New Elementary School in Foster City

for the San Mateo–Foster City School District

November 1, 2017 Final Environmental Impact Report

Figure 3-5
Conceptual Site Plan

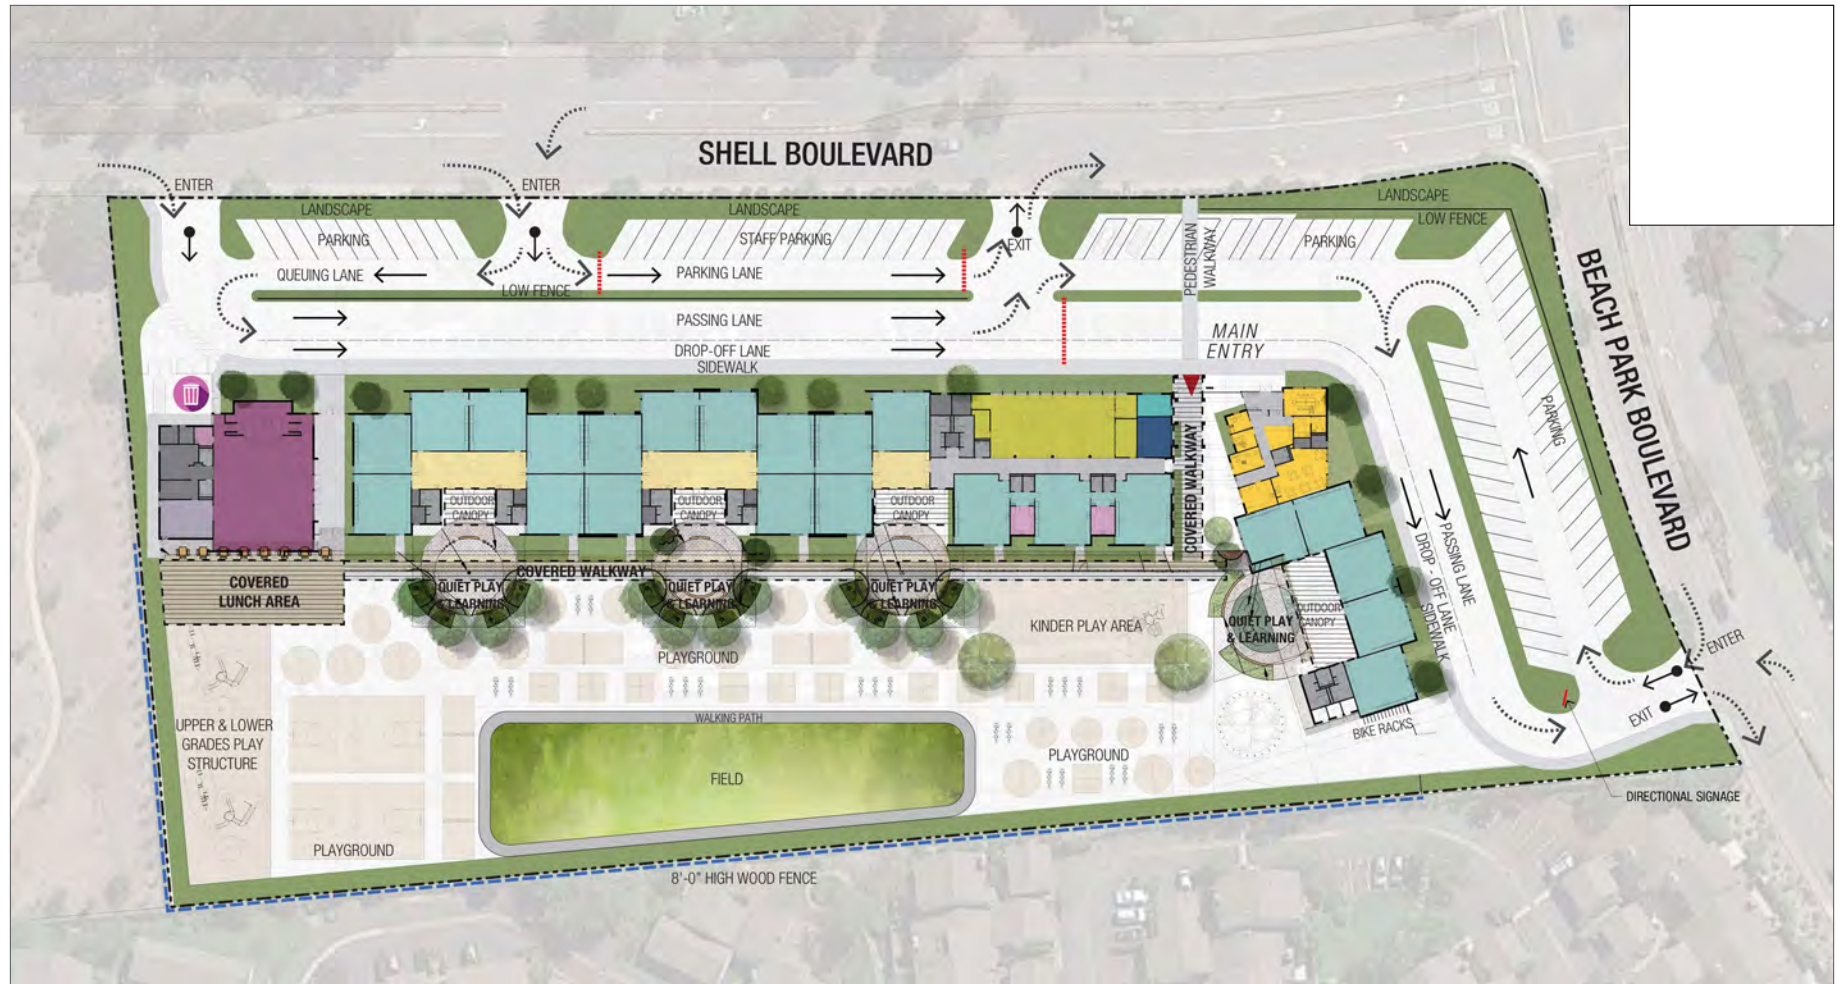
A01-16		The wrong figure is referenced in paragraph 3, page 3-12. The reference should be to Figure 3-4 not Figure 3-5.	The Figure reference has been corrected on page 3-12 of the Draft EIR.
A01-17		Paragraph 3 of page 3-12 should clarify whether the referenced access driveways are existing or new	The text on page 3-12 of the Draft EIR has been revised to state that the referenced driveways currently exist.
A01-18		and if existing, whether/how these driveways would be improved and specifically what work would be required in the City right-of-way.	This comment recommends additional detail concerning improvements to existing driveways in the Project Overview section of the Project Description. As no improvements are proposed, the subject was not included. In addition, as stated on page 3-1 of the Draft EIR, "Additional descriptions of the environmental setting as they relate to each of the environmental issues analyzed in Chapter 4, Environmental Assessment, are included in Subchapters 4.1 through 4.14." These subject of driveways is included in Chapter 4 subchapters that include analyses to which that information is relevant, including: Subchapter 4.13 Transportation and Traffic

Figure 3-5, Conceptual Site Plan, on page 3-10 of the Draft EIR has been revised to include more detail concerning site circulation, as shown on the following page.
